Brussels, 30<sup>th</sup> October 2019

**Subject: Actility's view on the Formal public consultation of the CRM Design Notes (Part II)**

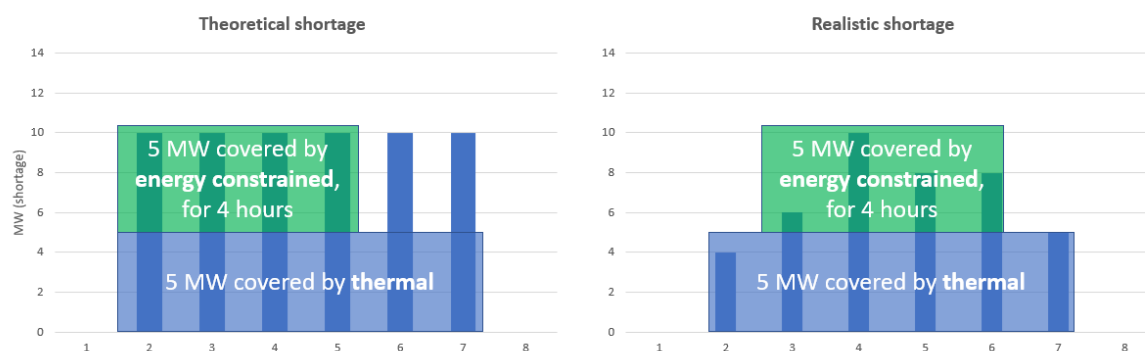
Lastly, Actility would like to point out a risk in the currently proposed methodology to calculate the derating factors for energy-limited technologies. In the proposed calculation methodology it is implicitly assumed that additional energy-limited capacity would need to be activated for the whole duration of a near-scarcity moment,

it assumes thus scarcity as a lumpy block. In reality, there will be an interplay with capacity which can provide a “base-load” during a near-scarcity moment while additional energy-limited capacity can cover the “peak-scarcity moments” (right part of figure). This can be illustrated by the following figure where a scarcity moment of six hours is shown. On the left, there is a theoretical shortage of 60 MWh while on the right, there is a more realistic shortage of 41 MWh.

Underestimating the contribution of energy-limited capacity will lead to more nominal volume contracted and thus a higher price of the CRM-scheme. The derating factor of energy-limited assets should thus be determined with great care, taking into account the spiky nature of a shortage.

**Recommendation:** We recommend to reconsider the methodology for the calculation of the derating factor of energy-constrained units, explicitly taking into account the spiky nature of shortages.
